AGENDA
COMMITTEE OF THE WHOLE
May 21, 2019
2200 Harnish Drive
Village Board Room
- AGENDA -
7:45 P.M.

SUBJECT: **Case No. 2019-07. OrthoIllinois Algonquin – Final PUD Amendment**

**ORTHOILLINOIS - ALGONQUIN CLINIC
PARKING LOT EXPANSION
SITE GEOMETRY & UTILITY PLAN**

**ORTHOILLINOIS - ALGONQUIN CLINIC
 PARKING LOT EXPANSION
 SITE LANDSCAPE PLAN**

DESIGNED DMS	DRAWN KLN
PROJECT NO. 00703-7-19-00114	
DATE APRIL 15, 2019	
SHEET NO. L1

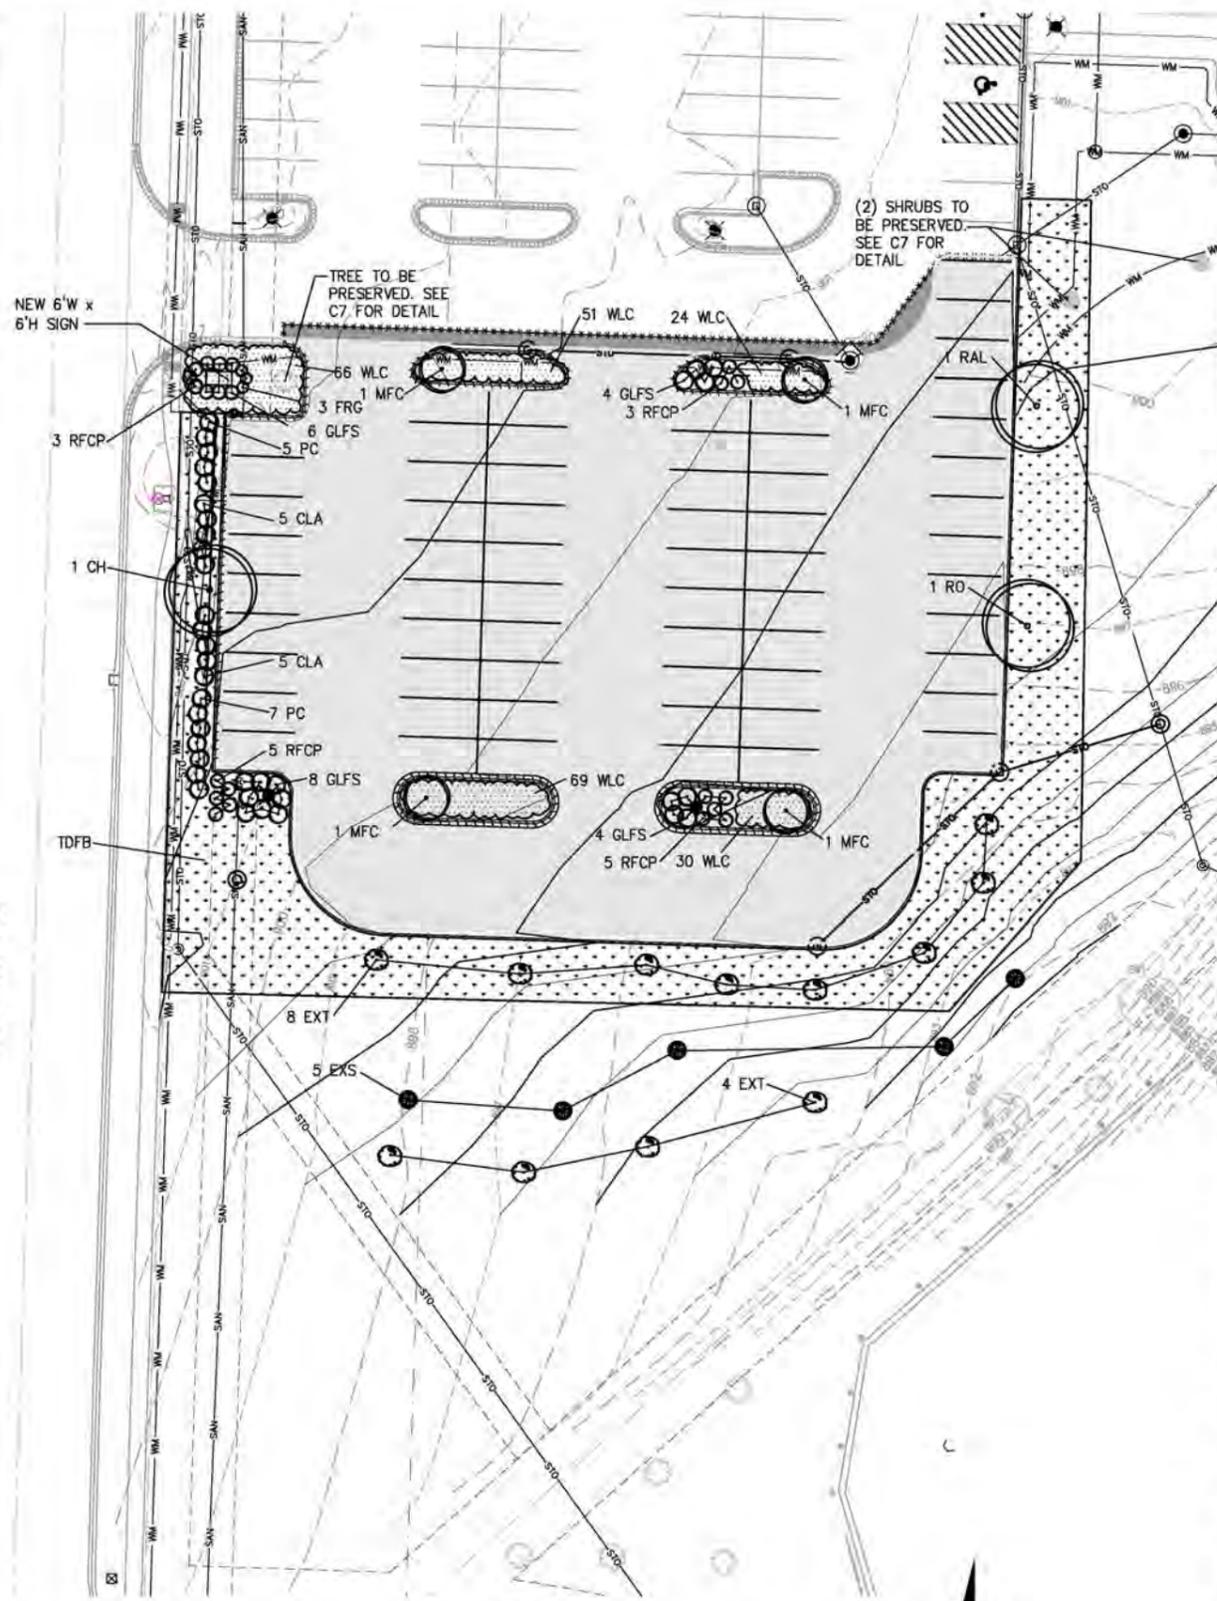
- L1 Only utilize trees from the Village approved tree list
(https://www.algonquin.org/egov/documents/1490967146_24991.pdf)
- L1 Add perennial flowers (2 species) to monument sign location

- L1 Village recommends adding a few more trees along the East parking lot perimeter
- E3 Considering it is likely that you will need to open cut a trench from the existing light fixture system to the new system, it is highly recommended you show the pavement removal on the demo sheet, and patching on the pavement plan. In addition, please verify that there is no conflict at the crossing of the proposed electrical conduit extension and the proposed storm sewer extension.

10. The shading used for the restoration of the turf area is not defined on the plan sheet. The work proposed on this sheet shall be consistent with the information provided on sheet C2 of the Engineering Improvement Plans.
